# Access Compliance Report

## Public Rights-of-Way

### (Pedestrian Signals)

Intersection ID: N/A	Main Street:	Cross Street: N/A	Location: N/A
ADA ID: 4DB00FCFF872	Signal Type: One Push Button-Non APS	Overall Compliance: No	Severity Score: BTN 1: N/A BTN 2: N/A No BTN: N/A
Codes/Mitigation Info/Possible Solution		Field Measurements/Component Compliance

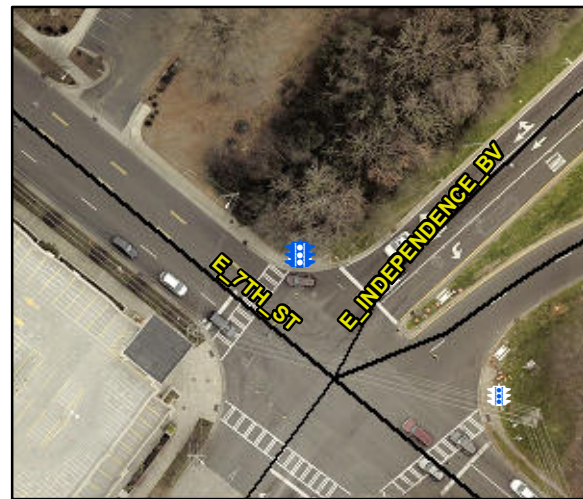
PROW/ADA: TMUTCD 4e.08, R404.2, R404.3, R404.7.3

Yes	B 1 Clear Xing Direction?	ClearlyMarked	N/A	B 2 Clear Xing Direction?	N/A
	B 1 Crossing Direction	To SW		B 2 Crossing Direction	N/A
Yes	B 1 DistanceTo XWalk (in)	13.0	N/A	B 2 DistanceTo XWalk (in)	N/A
No	B 1 DistanceTo Curb (in)	77.0	N/A	B 2 DistanceTo Curb (in)	N/A
Yes	B 1 Diameter (in)	2.0	N/A	B 2 Diameter (in)	N/A

Possible Solutions: Replace Signal Push Button With APS Button on New Post. Remove & Relocate Sign.
